Serial: RA-21-0254
December 9, 2021

H. B. ROBINSON STEAM ELECTRIC PLANT, UNIT NO. 2
DOCKET NO. 50-261 / RENEWED LICENSE NO. DPR-23

**SUBJECT: Correction to Non-Conservative Technical Specifications Figure 3.4.3-2,
Pressure/Temperature Limit Cooldown Curves**

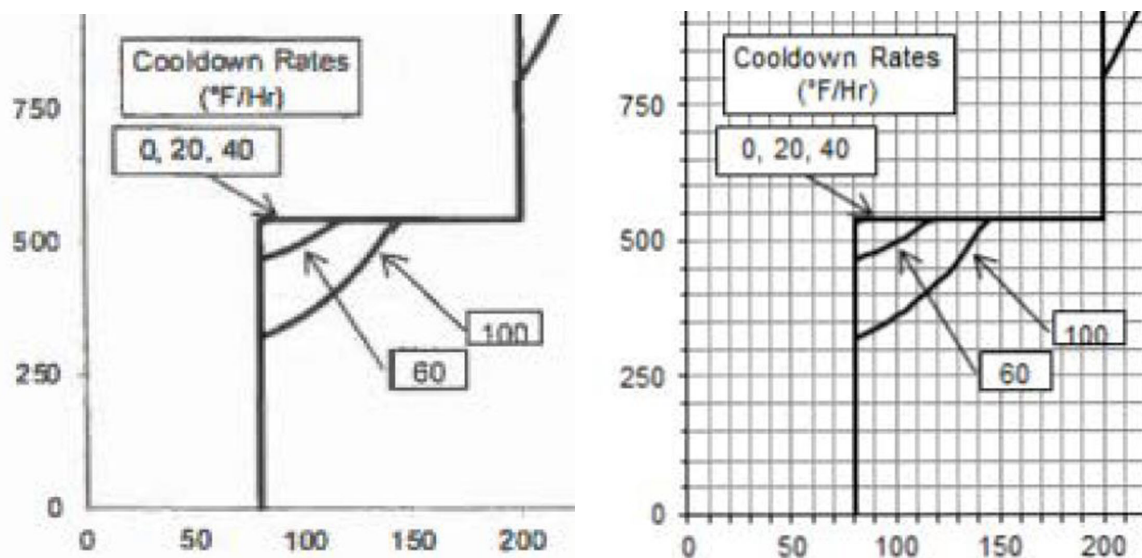
A portion of TS Figure 3.4.3-2 (P/T limit cooldown curves) is being corrected because it does not reflect the P/T limit data approved in Amendment No. 248 (Reference 1). Specifically, the portion of Figure 3.4.3-2 being corrected is the 60°F/hr and 100°F/hr curves at temperatures below 150°F.

The following example illustrates the correction needed to Figure 3.4.3-2 (note that the stated values include the +20°F and -80 PSIG adjustment for instrumentation error on top of the WCAP-15827 Table 28 data). It can be seen from Table 28 of WCAP-15827 that the 100°F/hr curve should start its downward trajectory from 541 PSIG at 150°F, but Figure 3.4.3-2 shows it starting at approximately 145°F. Similarly, the 60°F/hr curve should start its downward trajectory from 541 PSIG at 125°F, but Figure 3.4.3-2 shows it starting at approximately 115°F.

Below is a closeup of Figure 3.4.3-2 for convenience (horizontal axis is temperature; vertical axis is pressure). The left-hand closeup is from the current RNP TS; the right-hand closeup is from the Reference 2 amendment request, included as a visual aid due to the inclusion of gridlines.

The proposed change revises the 60°F/hr and 100°F/hr curves to reflect the WCAP-15827 Table 28 data.

Figure 3.4.3-2
Reactor Coolant System Cooldown Limitations
Applicable Up to 46.3 EFPY

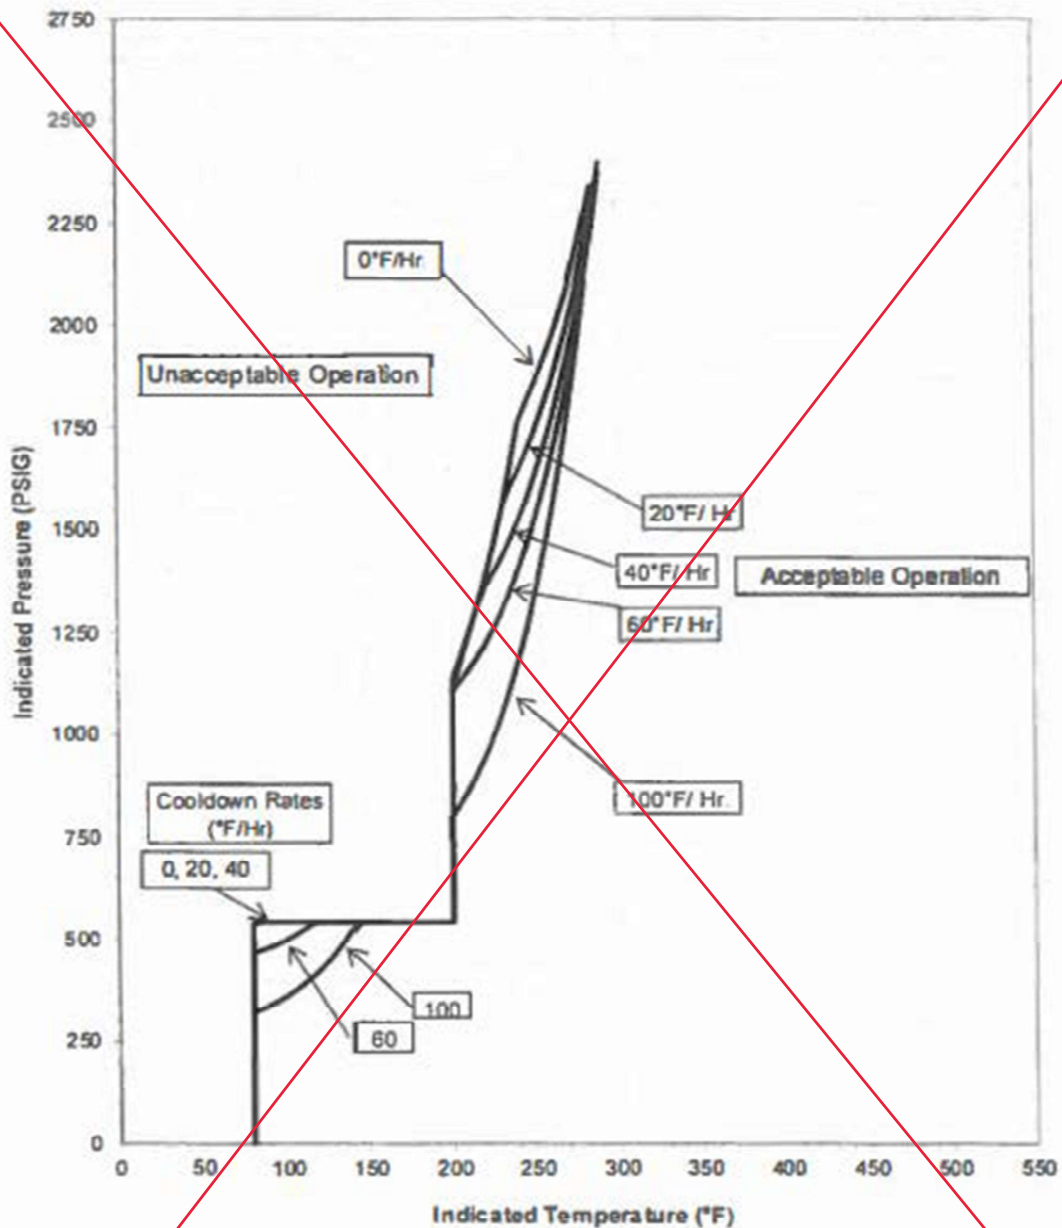
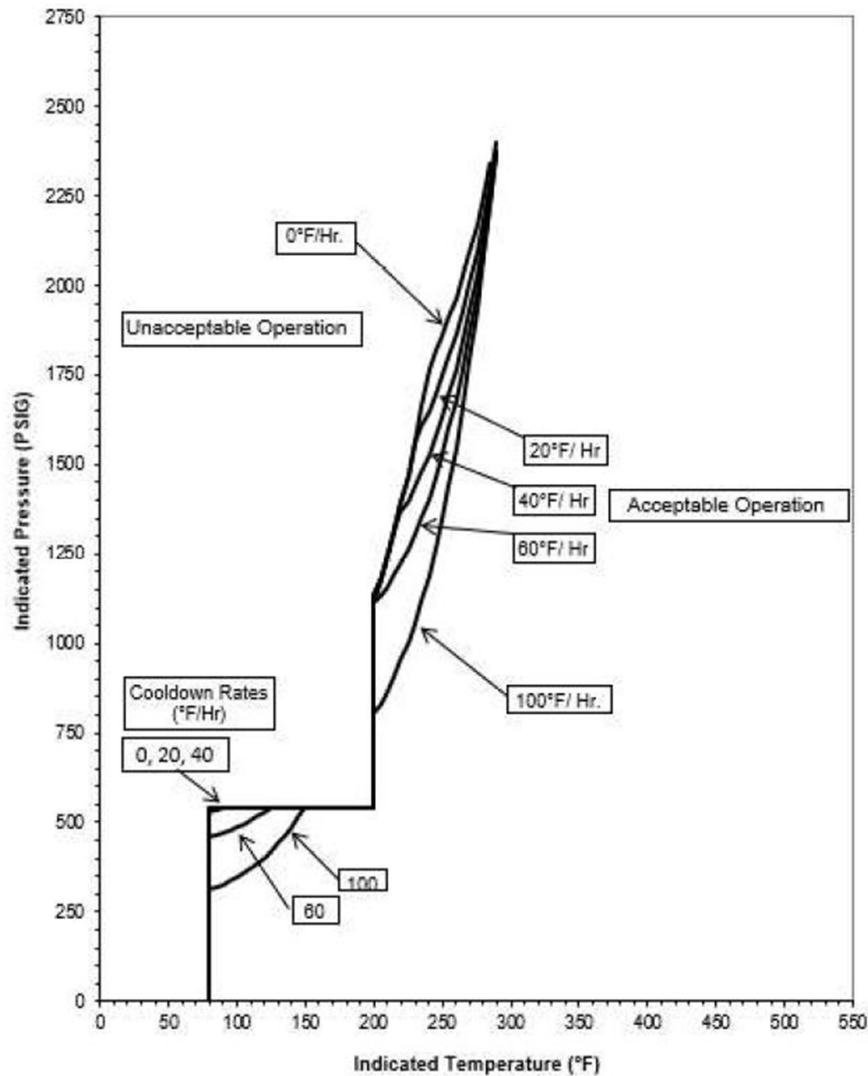
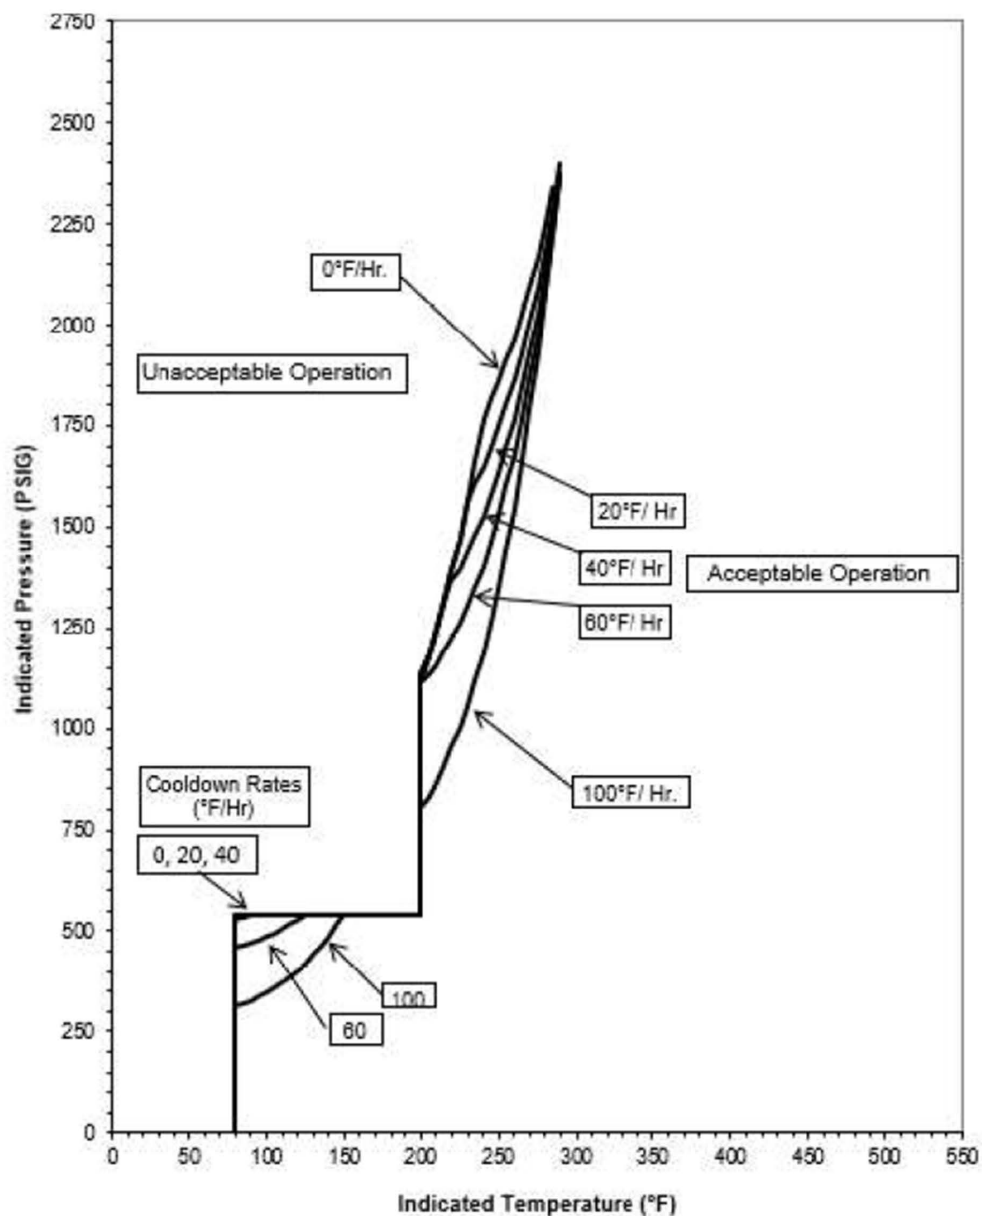
Replace with INSERT 1

INSERT 1
